## Portishead Branch Line (MetroWest Phase 1)

### 9.3.5 ExA.SoCG-HE.D1.V1 – Statement of Common Ground

- (1) North Somerset District Council; and
- (2) Historic England

**Date: November 2020**

### Location plan

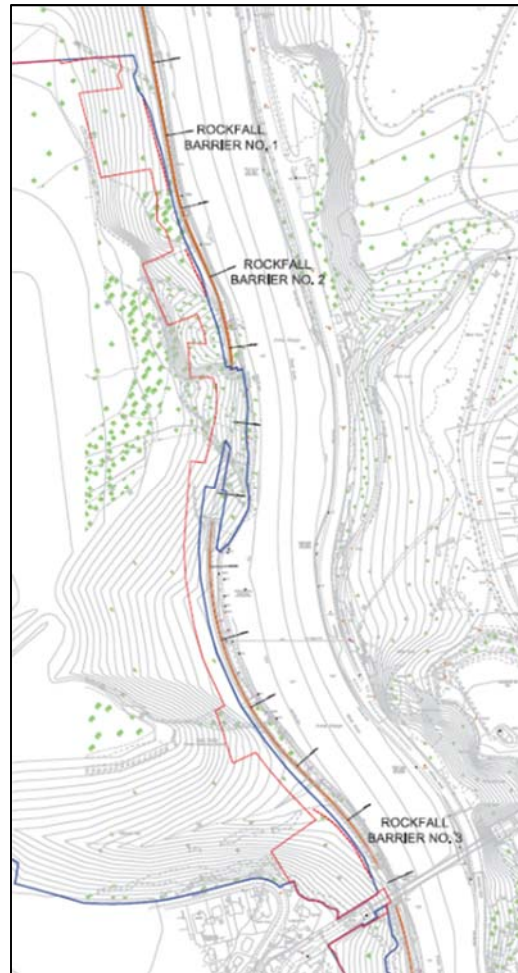
Historic England raised concerns regarding impacts to heritage assets from possible rock bolting and rock catch fencing through the Avon Gorge.

Network Rail produced revised designs for the rock catch fencing near the Clifton Suspension Bridge in May 2020.

Details of rock bolting and catch fencing has been included in the Report to inform Habitats Regulations Assessment (ES Volume 4, Appendix 9.12 DCO Document Reference 6.25) and on the General Arrangement Plans Sheets 9 to 13 (DCO Document Reference 2.4).

- Rockfall barrier No. 1 is located south of Quarry Underbridge number 3. It is positioned up the cliff slope from the railway line within the existing trees.
- Rockfall barrier No. 2 is located north of Quarry Underbridge number 2. It is positioned up the cliff slope from the railway line within the existing trees.
- Rockfall barrier No. 3 is located between the base of the Clifton Suspension Bridge by the tunnel and Nightingale Valley. It is positioned up the cliff slope from the railway line within the existing

It can be seen from the photographs that the rockfall barriers would be located within the existing woodland and therefore well screened from view by the planting. There would be some localised vegetation removal to allow their installation, primarily for working space and access, but this

The mesh material used for the barriers is relatively transparent and therefore even if they are visible, the vegetation and ground behind the barrier would be visible through the mesh.
